**SKEWED ABUTMENT PLAN WITH WING EXTENSIONS**  
(SKEWED LEFT AHEAD SHOWN, SKEWED RIGHT AHEAD SIMILAR)

LATEST REVISION DATE 04-12	APPROVED BY BRIDGE ENGINEER <i>Thomas E. M. Donnell</i>		
		STANDARD DESIGN - 44' ROADWAY, THREE SPAN BRIDGE <b>PRETENSIONED PRESTRESSED CONCRETE BEAM BRIDGES</b> MARCH, 2007	
		<b>ABUTMENT BACKFILL DETAILS</b> C BEAMS - SKEWED	<b>H44-80-07</b>

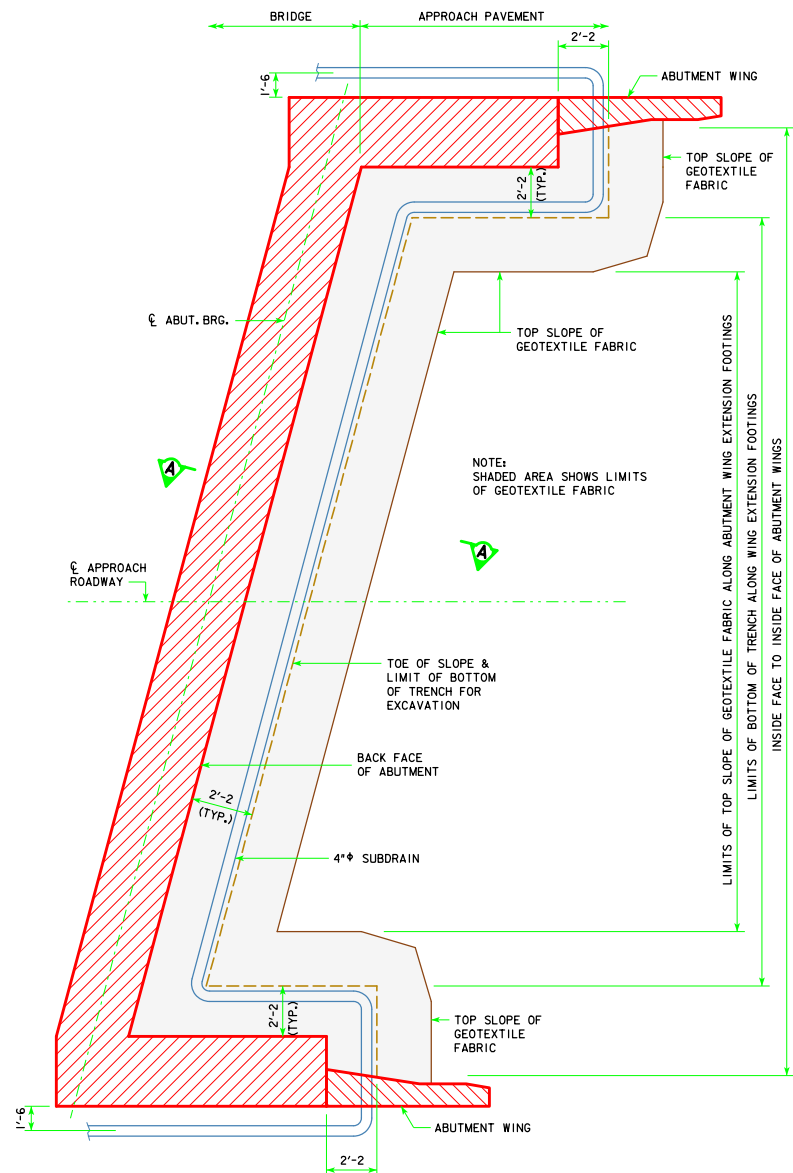
REVISED 04-12 - EXCAVATION LIMIT ON THE FRONT FACE OF THE ABUTMENT WAS CHANGED TO A 3'-0" LIMIT. THE APPROACH FILL WAS IDENTIFIED AS THE GRADING SURFACE.
